# Service Bulletin

Model:	Ref No.:	
iR3570 iR4570	iR4570-010	
	(F1-T01-0M4-10032-01)	
	Date:	
	25-02-05

Fixing Assembly

Preventive measure against display of E014 and abnormal sound generated from fixing assembly.

F-1

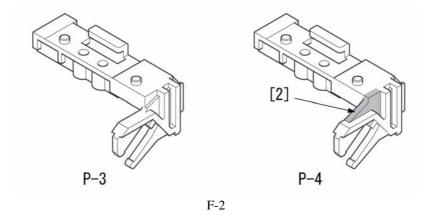
A cleaning roller mount, which is used to fix the cleaning roller, is damaged by a shock given in transport, and the cleaning roller is detached, that causes a malfunction.

The shape of cleaning roller mount is changed as shown below to increase its strength so as to prevent the cleaning roller mount from being damaged and prevent the cleaning roller from becoming a malfunction.

[1] Added parts to increase the strength

[2] Added part to increase the strength

When the symptom described above occurs, replace the cleaning roller mount unit to new one. Be sure to replace both (front/rear) of the cleaning roller mount unit even when only one side (front or rear) has been damaged, so as to prevent recurrence in future.
